Project	IEEE 802.16 Broadband Wireless Access Working Group < http://ieee802.org/16 >	
Title	Transmission schemes for 2 or more antenna MSS in UL	
Date Submitted	2004-08-16	
Source(s)	<i>Koo-Hyun Um, Inkyu Paek, Pyung-Su Park</i> hanaro telecom 470-9, Shindaebang-dong, Dongjak-gu, Seoul, Korea	Voice: 82-2-6266-5266 Fax: 82-2-6266-5309 [mailto:pspark@hnaro.com]
Re:	<i>This is a response to a Call for Comments IEEE802.16e-05/xx on IEEE P802.16e-D4</i>	
Abstract	<i>Transmission schemes for 2 or more antenna MSS in UL</i>	
Purpose	This document is submitted for review by 802.16e Working Group members	
Notice	This document has been prepared to assist IEEE 802.16. It is offered as a basis for discussion and is not binding on the contributing individual(s) or organization(s). The material in this document is subject to change in form and content after further study. The contributor(s) reserve(s) the right to add, amend or withdraw material contained herein.

Transmission schemes for 2 or more antenna MSS in UL

Figure xxx - Uplink pilot allocation for 4-antenna SS for the PUSC zones

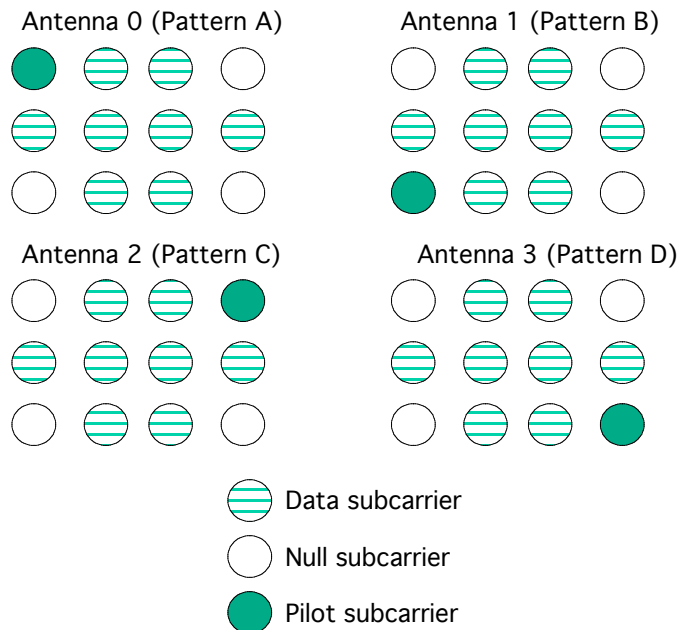
A user supporting transmission using STC configuration in the uplink, shall use a modified uplink tile, 4-transmit diversity data or 4-transmit spatial multiplexing data can be mapped onto each subcarrier. The mandatory tile shall be modified to accommodate those configurations. Figure xxx depicts the UL tile for STC transmission.

Four single transmit antenna SS's or two double transmit antenna SS's can perform collaborative spatial multiplexing onto the same subcarrier. In this case, each SS should use the uplink tile with each pattern A, B, C, D.

Figure aaa-1. Uplink pilot allocation for 3-antenna SS for the optional PUSC zones

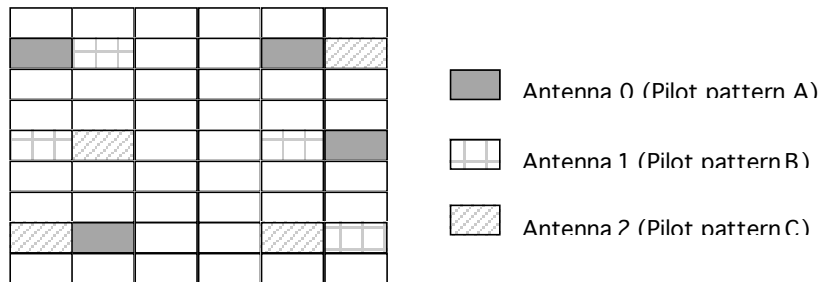
For 3-antenna SS and the optional PUSC, pilots for each antenna shall be allocated as shown in Figure aaa-1.

Figure aaa-2. Uplink pilot allocation for 4-antenna SS for the optional PUSC zones

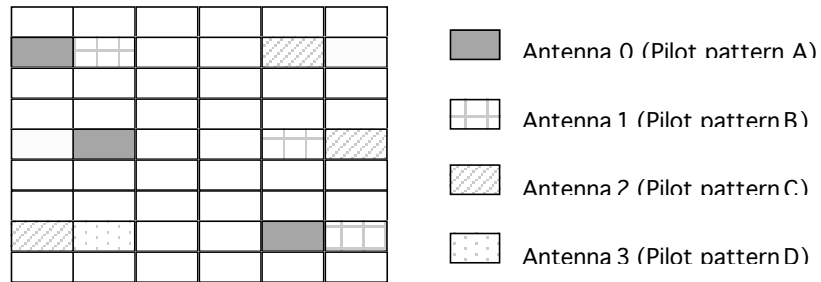
For 4-antenna SS and the optional PUSC, pilots for each antenna shall be allocated as shown in Figure aaa-2.

Figure aaa-3. Uplink pilot allocation for 4-antenna SS for AMC zones

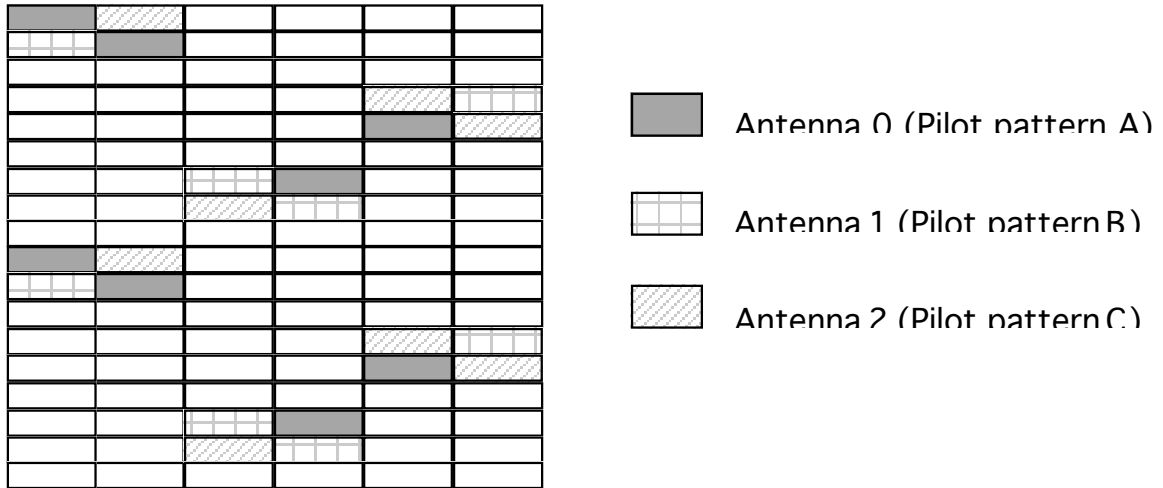
For 3-antenna SS and the AMC, pilots for each antenna shall be allocated as shown in Figure aaa-3.

Figure aaa-4. Uplink pilot allocation for 4-antenna SS for AMC zones

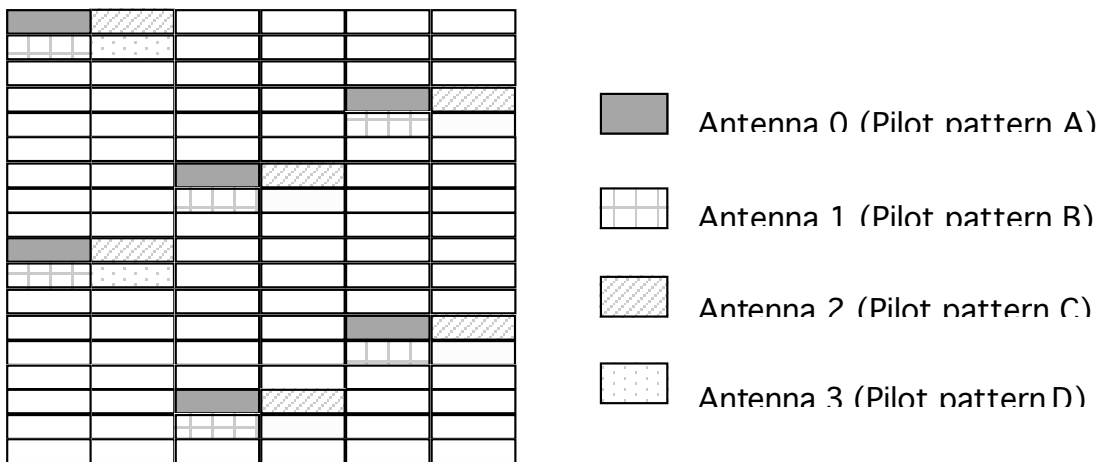
For 4-antenna SS and the AMC, pilots for each antenna shall be allocated as shown in Figure aaa-4.
